ANADROMOUS WATERS CATALOG/ATLAS
CORRECTION FORM

MAP: Sitka B-~~A~~

WATERWAY NUMBER: 113-65-10039 and -2005, -2009, -2010

DESCRIBE CHANGE(S): Changed 10039 to 10040-2001 and 10039-2005 to 10040-2001-3005 and -2009 to -3009 and -2010 to -3010 to match NHD hydro.

(See attached file: whitewater.jpg)

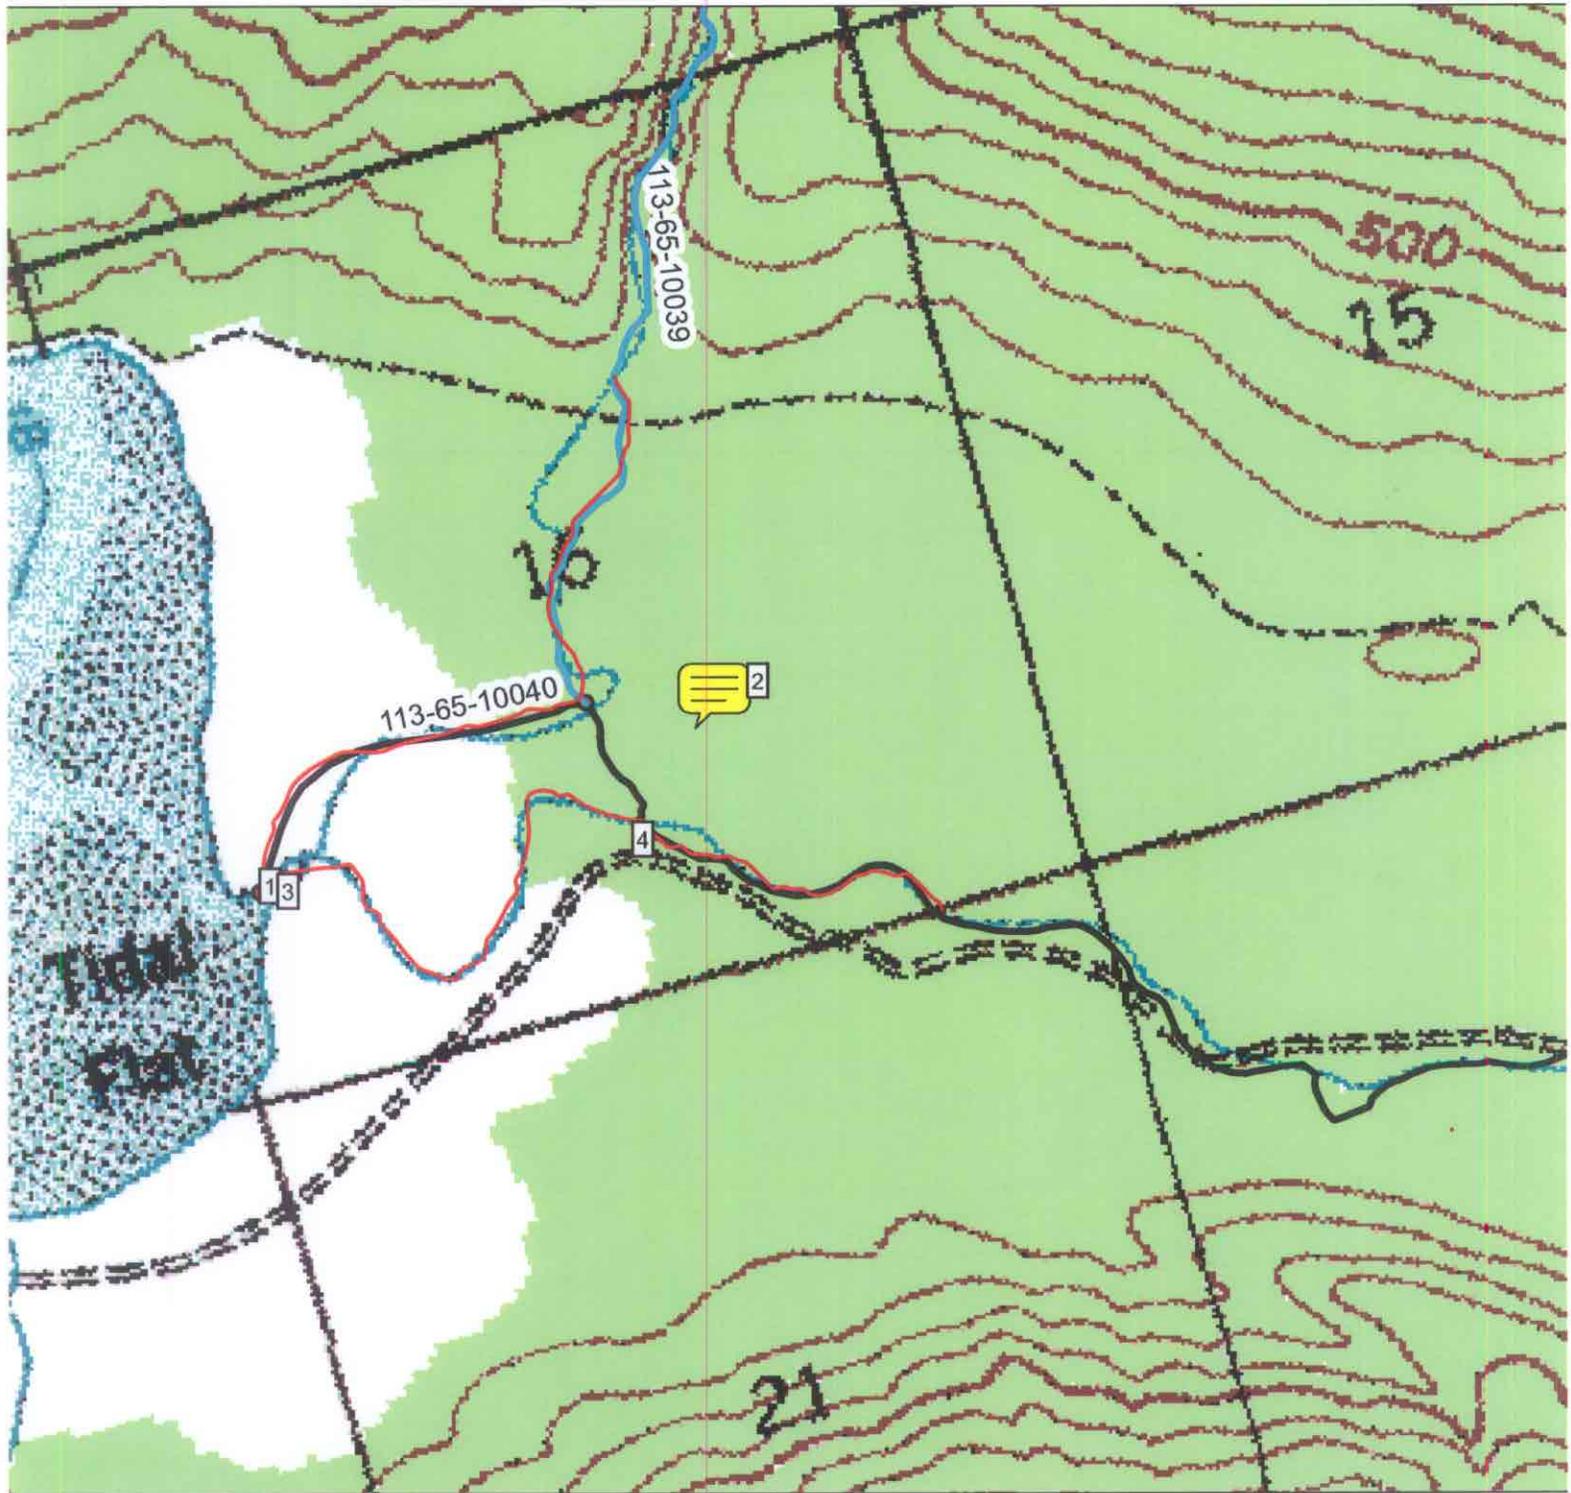
Mr. Johnson, the streams of the north watershed and the southern watershed are connected in the estuary via 'Unverified intertidal' (UI) and 'Unverified Connector' (UC) stream arcs, which are artifacts of the editing done to meet NHD routing requirements. I can see that the UC arc of the southeast stream network could have been digitized straight to the lowtide shoreline (pink line) without intersecting the north UI arc. I can make that edit in the Tongass hydrography but not in the NHD. Keeping the north separate from the south is consistent with our watershed boundary layer.
